**Benton
County**

Memo to the PLANNING COMMISSION

Application: Preliminary plat approval of a 9-lot subdivision on a 21 acre property in the RR-2 zone, with the proposed name of "South Anderson Blues Subdivision"

Subject: Answers to Planning Commission questions and some draft Conditions of Approval for Planning Commission consideration and editing

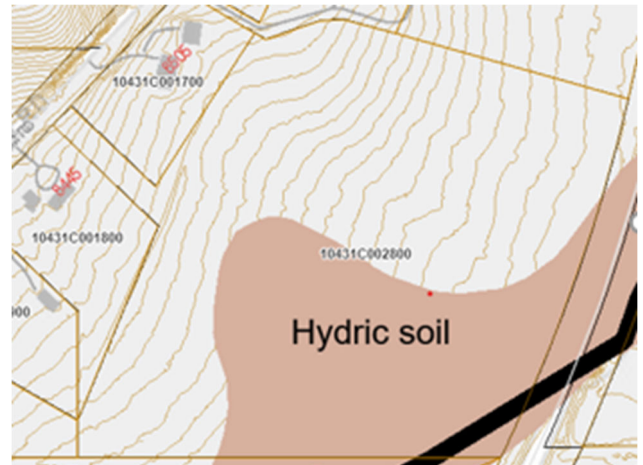
10. The applicant makes a compelling argument that the development immediately to the south would be only 4 lots, and Arbor Creek would separate these 4 lots from the adjacent 13 lots on the other side of Arbor Creek, and therefore the road easement is not necessary. Does Staff concur? Should Condition of Approval # 8 requiring enhanced connectivity to the south be kept?

Answer: From one perspective, a developer would likely try to avoid crossing Arbor Creek. Access to a development would be obtained via Arboretum Road, and the developer likely has no reason to avoid creating dead-ends and no reason to want to build a road over Arbor Creek. Although enhanced connectivity is required by BCC 99.515(1)(g): “Dead-end streets shall be designed to connect with future streets on adjacent property,” one could say that reserving this future right of way makes it more likely the stream will be crossed, which is beneficial for transportation connectivity but might be detrimental to the stream (although streams are frequently crossed by roads).

From another perspective, although it is often cheaper and involves less permits to avoid building roads over streams, it does happen. Within the past few weeks Staff has been working on a different housing development in which the developer chose to have a road cross the same stream twice, and that stream is even in the regulated floodplain, requiring even more permits. If the developer’s motivation is high enough, streams may be crossed. Connection of dead-end streets between properties is required by BCC 99.515(1)(g). Dedicating the land for a road at a later date when the connectivity need is imminent would be costly, time consuming, difficult, and most importantly, avoidable if appropriate measures had been taken when the

property was under one ownership with no structures built on the land yet. Pre-planning roads and infrastructure is an important aspect of efficient land use planning. No construction is required at this point, only the reservation for future right of way, which preserves options for the future.
